## Recall Information Bulletin

No: C10129 Issued: 2/25/2025

Safety Recall C10129 – Fuse Box Water Invasion

FEC7K (E16L/E16M), FEC9K (E18L/E18M)

# 1 Dry up process

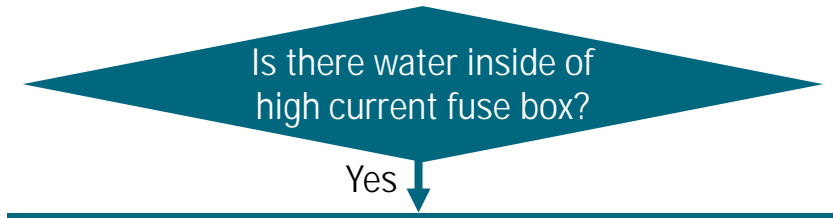
Remove the High Current Fuse Box from bracket and tilt it for collecting water.

Remove water inside of High Current Fuse.

Dry out the High Current Fuse Box three times with paper towels

Blow air at a distance of 30cm from High Current Fuse Box for longer than 1 min.

Remove the paper towels and keep the cover open. Close cover after no missing water was confirmed.

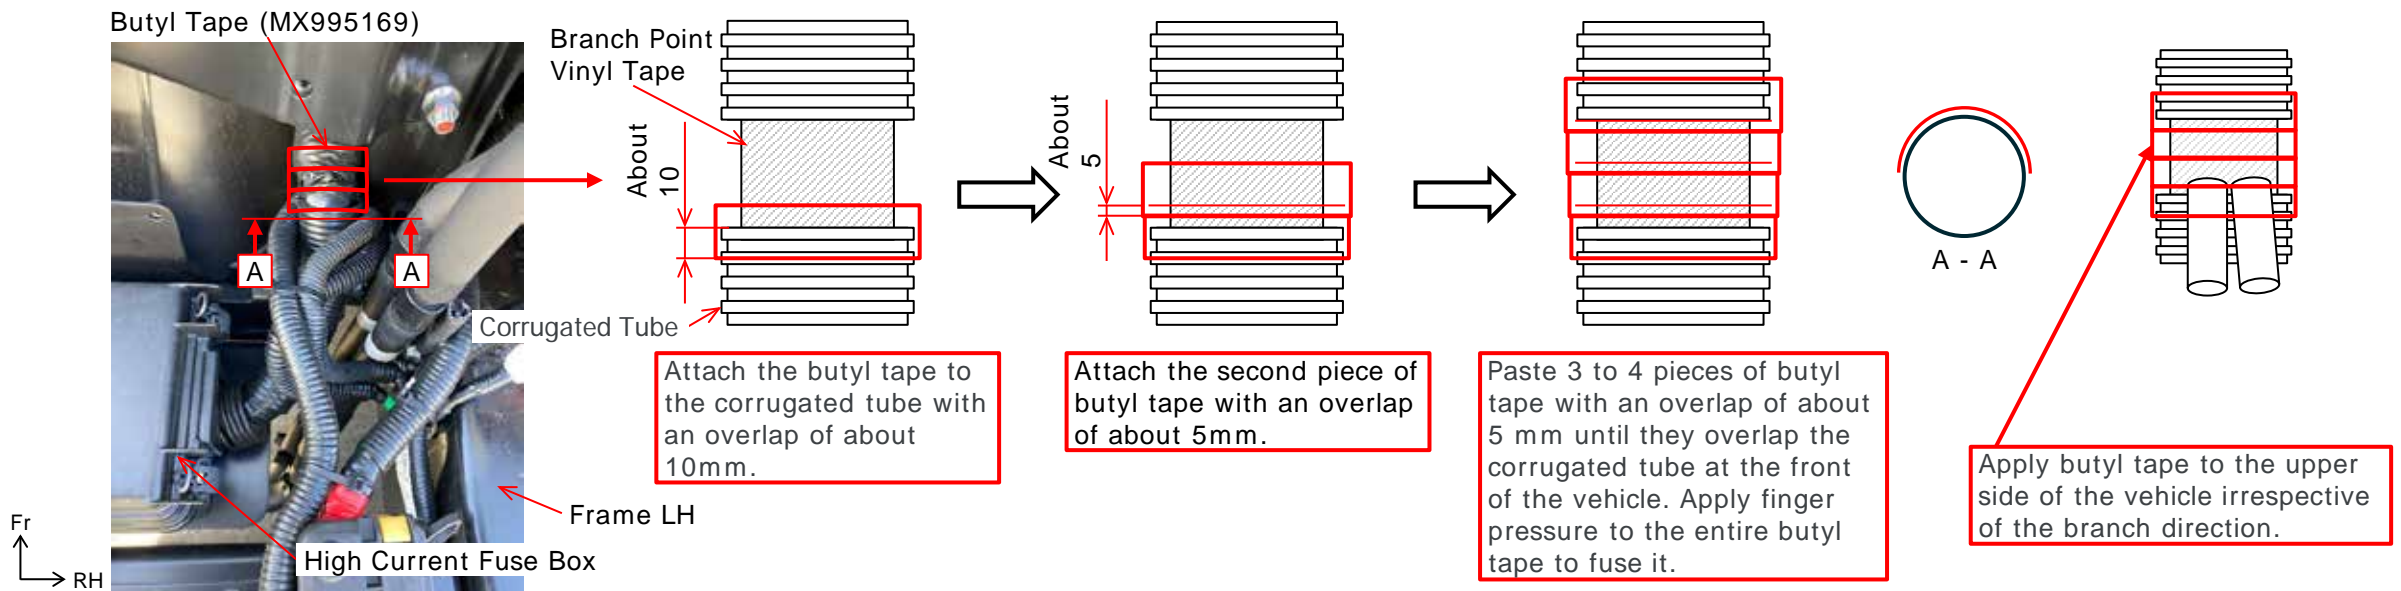
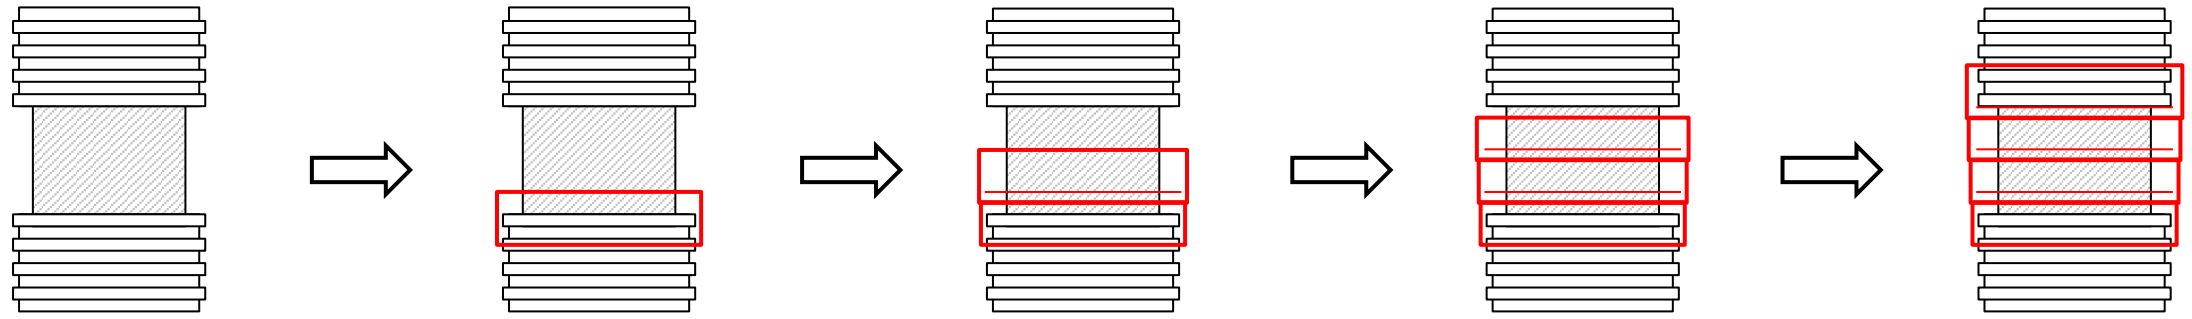
Apply butyl tape (MX995169) to the vinyl tape on the branch point.

Install a vinyl sheet 200 x 180 (MX995167) between the branch point and the high current fuse box.

Wrap the vinyl sheet (MX995167) around the harness.

Fix both ends of the vinyl sheet with bands (MK663741).

Install the vinyl sheet so that the overlapping part is on the bottom of the vehicle.

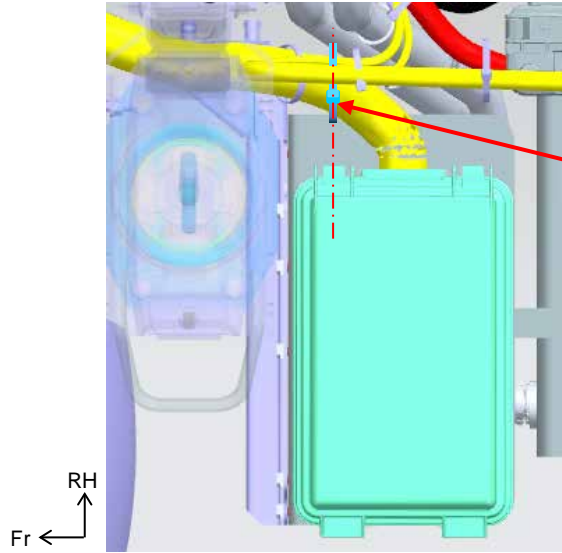
Install a vinyl sheet 200 x 200 (MX995168) over the harness branch point.

Fix the vinyl sheet with the band (MK663741).

Align the end of the vinyl sheet (MX995168) with the existing harness fixing band and wrap it around the harness.

Install the vinyl sheet so that the overlapping part is on the bottom of the vehicle.

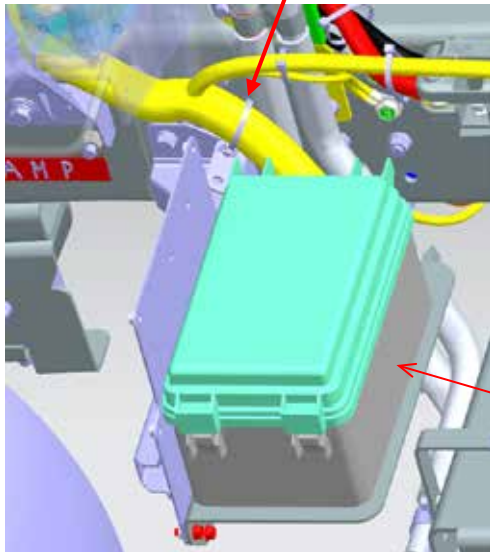
Fix the vinyl sheet to the harness with the band (MK663741) in line with the position of the vehicle front side clamp of the high current fuse box lid.

Fix harness to bracket with band clip (MK677891).

If the band clip is too short to fix the harness, use two band clips to fix the harness.
